## SUDAS Revision Submittal Form

<b>Status Date:</b>	As of 5/17/2019	<b>Topic:</b>	Rock subbase
<b>Manual:</b>	Specifications	<b>Manual Location:</b>	6010, 3.01; Figures 6010.302-305, 401-406, and 501-513

FIGURE 6010.304 SHEET 1 OF 2

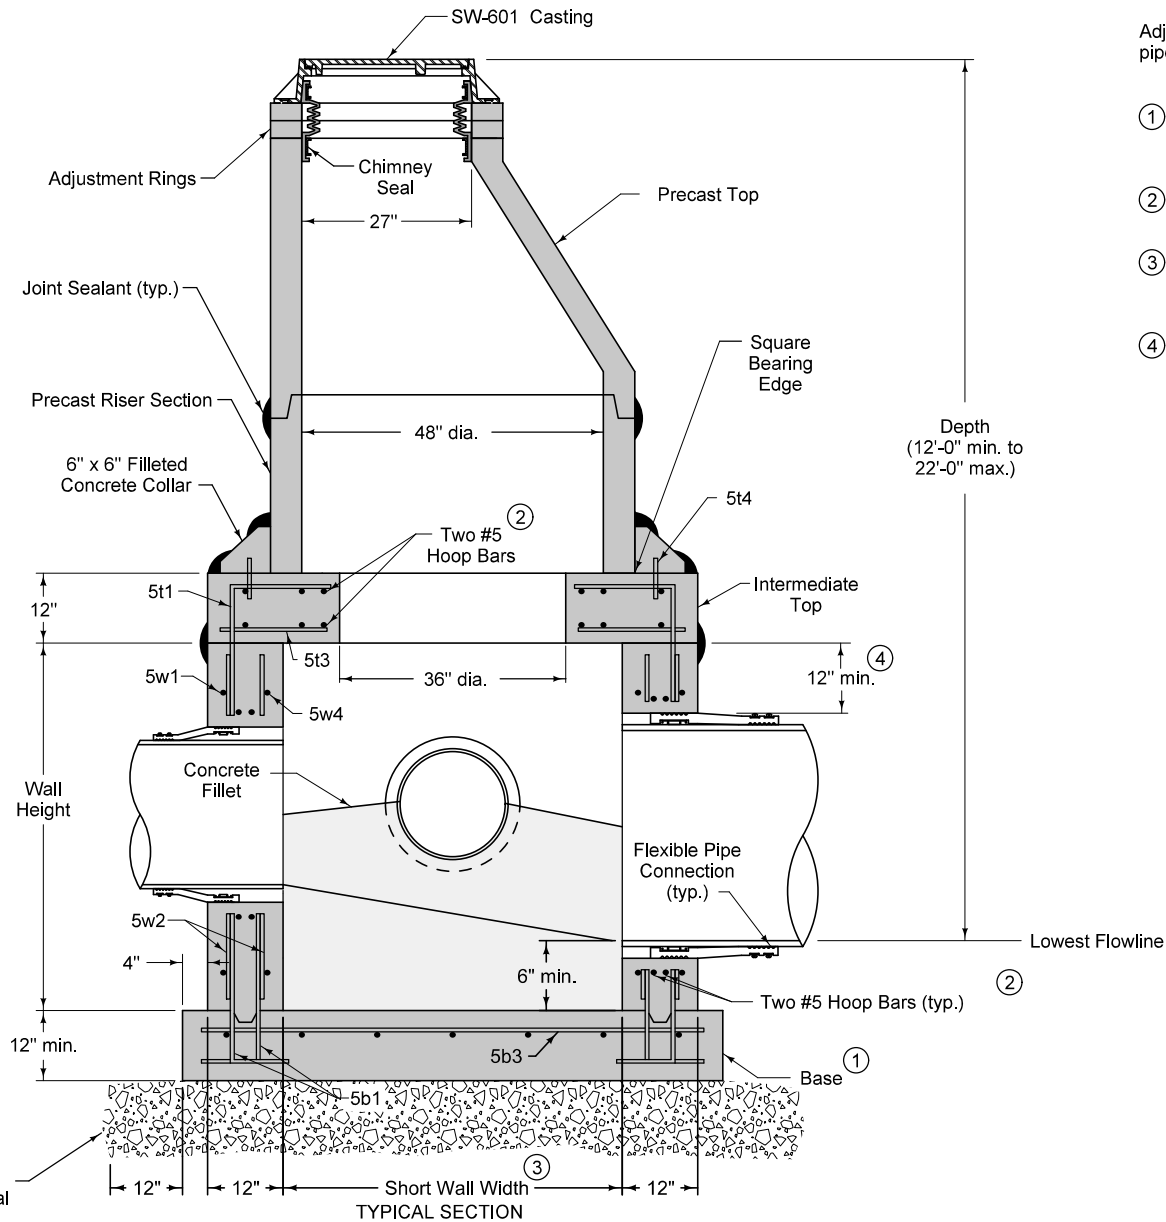
**Reason for Revision:** Added rock subbase to all cast-in-place structures to match precast structures.

<b>District:</b>	<input type="checkbox"/> 1	<input type="checkbox"/> 2	<input type="checkbox"/> 3	<input checked="" type="checkbox"/> 4	<input type="checkbox"/> 5	<input type="checkbox"/> 6
<b>Comments:</b>	12" rock subbase dimension on example figure is in the wrong place. <i>Note - fixed.</i>					
<b>Action:</b>	<input type="checkbox"/> Deferred		<input type="checkbox"/> Not Approved		<input checked="" type="checkbox"/> Approved	
<b>District:</b>	<input type="checkbox"/> 1	<input type="checkbox"/> 2	<input checked="" type="checkbox"/> 3	<input type="checkbox"/> 4	<input type="checkbox"/> 5	<input type="checkbox"/> 6
<b>Comments:</b>	None.					
<b>Action:</b>	<input type="checkbox"/> Deferred		<input type="checkbox"/> Not Approved		<input checked="" type="checkbox"/> Approved	
<b>District:</b>	<input checked="" type="checkbox"/> 1	<input type="checkbox"/> 2	<input type="checkbox"/> 3	<input type="checkbox"/> 4	<input type="checkbox"/> 5	<input type="checkbox"/> 6

**C. Subbase:** Install 8 inch thick pad of Class I bedding material a minimum of 12 inches outside footprint of the structure.
